Responses to Public Comments on EPA's:

Standards of Performance for Municipal Solid Waste Landfills and Emission Guidelines and Compliance Times for Municipal Solid Waste Landfills: Proposed Rules

July 2016

Figure 1. Comparison of Methane Emission Results from CRDS Measurement (error bars represent 1std)

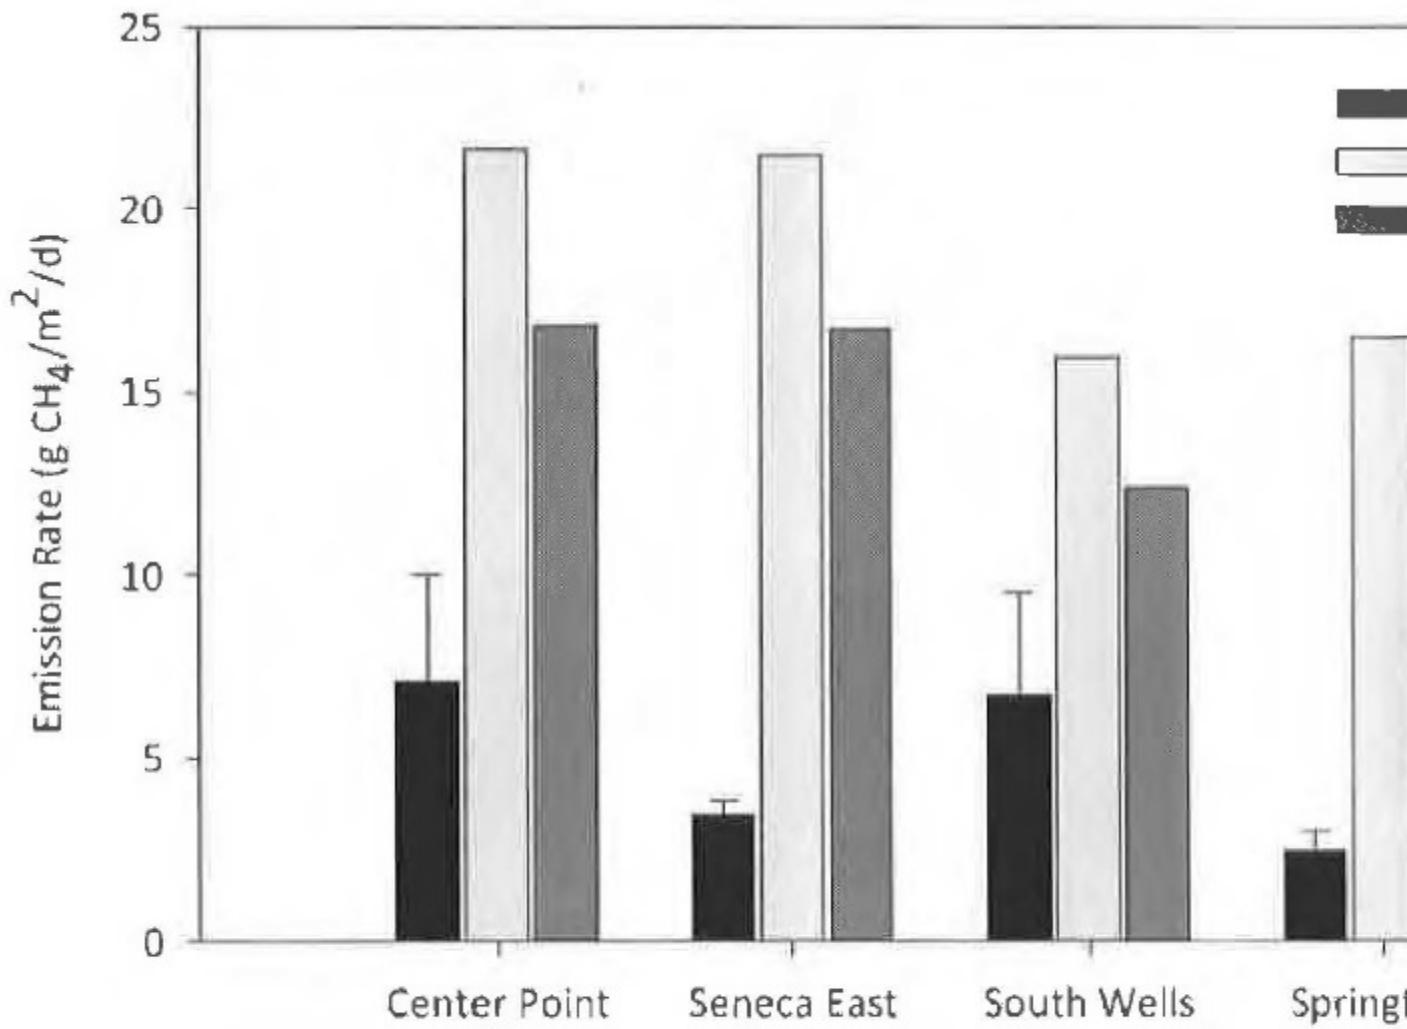
The analysis compared measured emissions to modeled emission rates using the EPA Greenhouse Gas Reporting Rule methodology in the 2010 rule, which used a default value for methane oxidation of 10 percent. The measured emissions were also compared to modeled emissions using the Solid Waste Industries for Climate Solutions ("SWICS") methodology, which uses a higher methane oxidation value of 30 percent (EPA has since adopted a higher range of oxidation values from 10% to 35% in the GHG Rule in 2013.). The study results, illustrated in Figure 1, showed that modeled emissions are two to four times higher than the measured emissions at the four closed landfills, indicating that EPA's modeled emissions are overly conservative. This finding is important because landfills can only manage the LFG they generate. If the models over-predict the amount of LFG produced at a site, the emission benefits of lowering the design capacity threshold would be overstated and the costs will likely be understated.

Comment Response:

Figure 1. Typical monitoring pathway on landfill surface.⁴¹

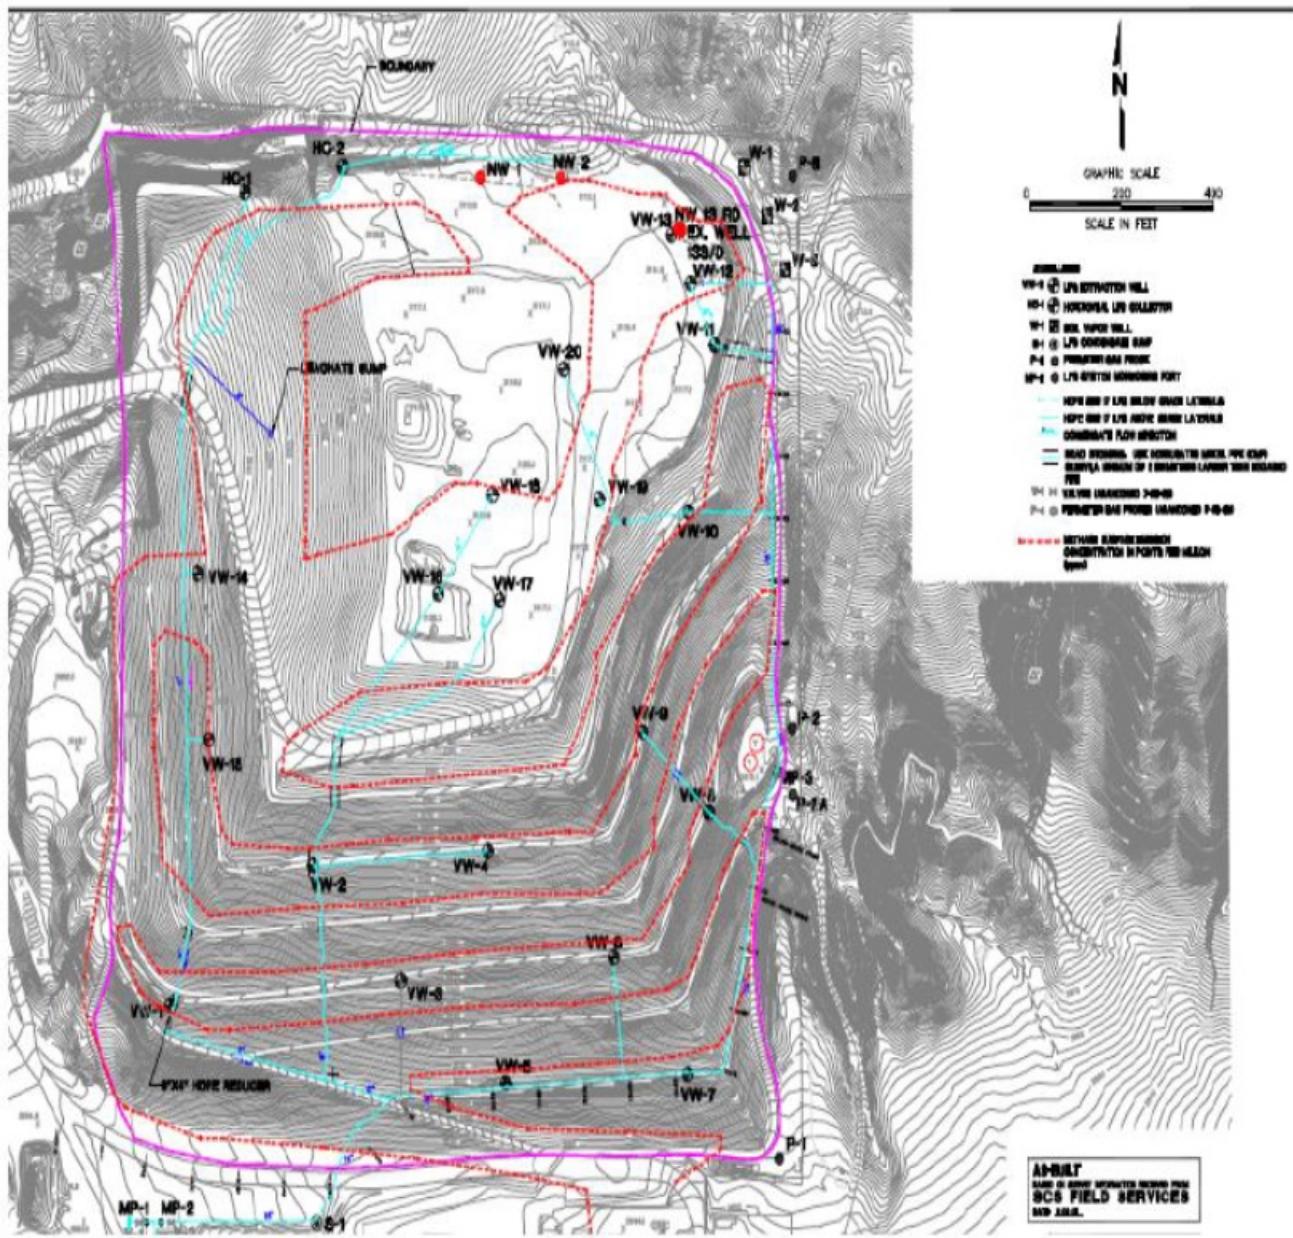
EPA's current regulations are much less protective than the California LMR, requiring quarterly monitoring with a handheld analyzer using walking intervals spaced as much as 30 meters apart (almost 100 feet). As the sample landfill diagram in Figure 1 below indicates, this walking pattern leaves most areas of the landfill unmonitored. Given the possibility of high emissions from localized cover defects, EDF believes it is essential that the revised NSPS and EG require comprehensive monitoring of the landfill surface similar to that provided in the California LMR.

Comment Response:
